ControlLogix® Redundancy System Revision 8

Cat. No. 1756-CNB/D, -CNBR/D, -L55, -L55M13, -L55M14,
-L55M16, -L55M23, -L55M24, 1757-SRM/A, -SRM/B

Introduction

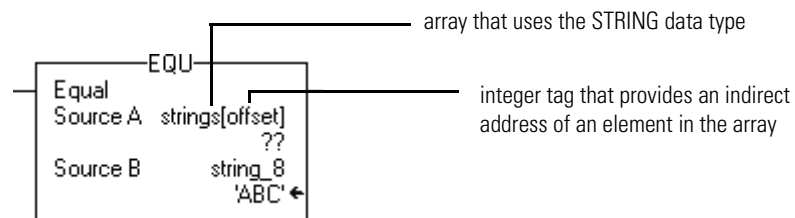
Indirect Addressing of an ASCII String You *cannot* download a project that uses an indirect address (tag in the subscript of an array) to a string data type, as follows:

For these instructions:	Avoid indirect addresses to these data types:
ARD, ARL, AWA, AWT	any user-defined string data type (The default STRING data type is OK.)
EQU, NEQ, LES, LEQ, GRT, GEQ	all string data types (including the default STRING data type)

For example, the following combinations of tags and instruction would prevent a project from downloading:
